BCA ASSESSMENT REPORT

**Oakdale West Estate, Kemps Creek
Building 2C & 2D**

**Prepared For:
Goodman Property Services (Aust) Pty Ltd**

Revision 2

Figure 1 – Perimeter Vehicular Access per BCA C2.4.

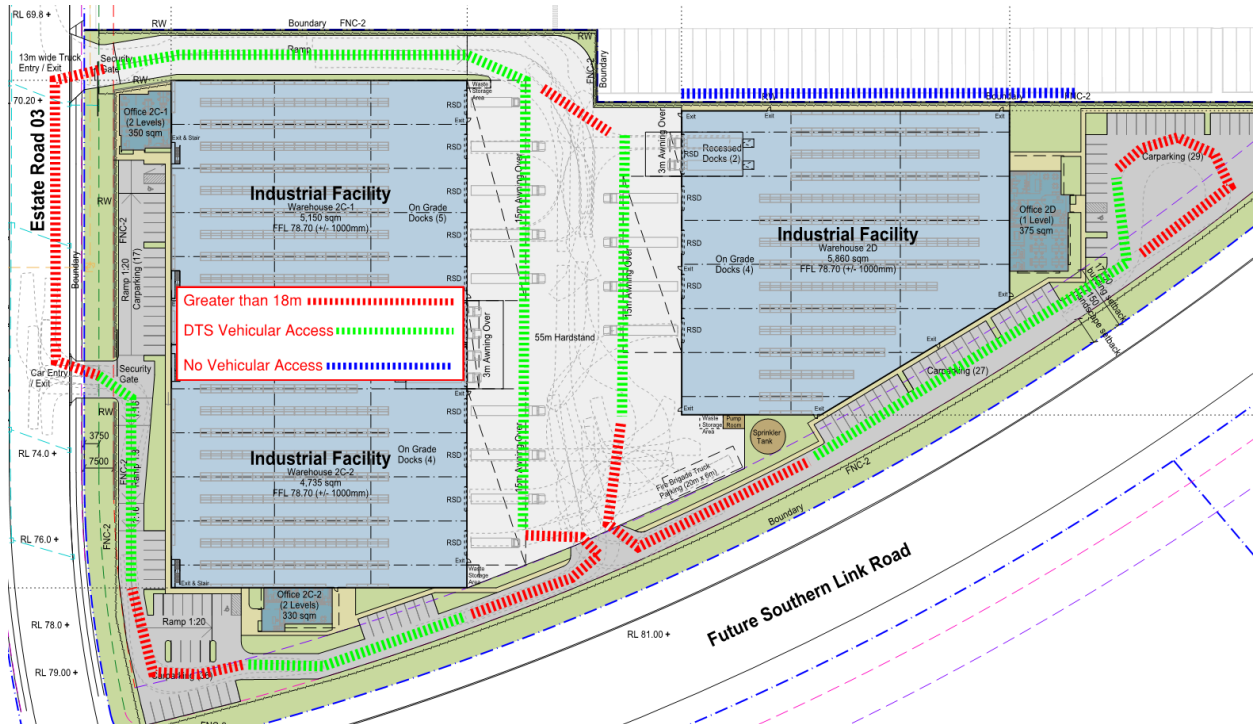
Comments: The proposed buildings do not comply with the provisions of C2.4 and thus the following non-compliance areas are identified on the site plan (over page) that are required to be addressed as an Performance Solution by the Fire Safety Engineer for each building, as follows:

- *Perimeter Vehicular Access is greater than 18m from the external walls of Building 2C & 2D as shown in red below.*
- *Perimeter Vehicular Access is not provided to northern external wall of Building 2D (three-sided access only).*

Note 1: The driveways providing vehicular perimeter access must be designed with adequate loading capacities to withstand a fire truck and the gradients of the ramps should take into consideration to the FRNSW Policy 4 Vehicular Access Guideline.

Note 2: If the perimeter access paths are reduced to less than 6m in width to accommodate pedestrian egress paths per Clause D1.10 below, this will need to be documented in the Performance Solution.
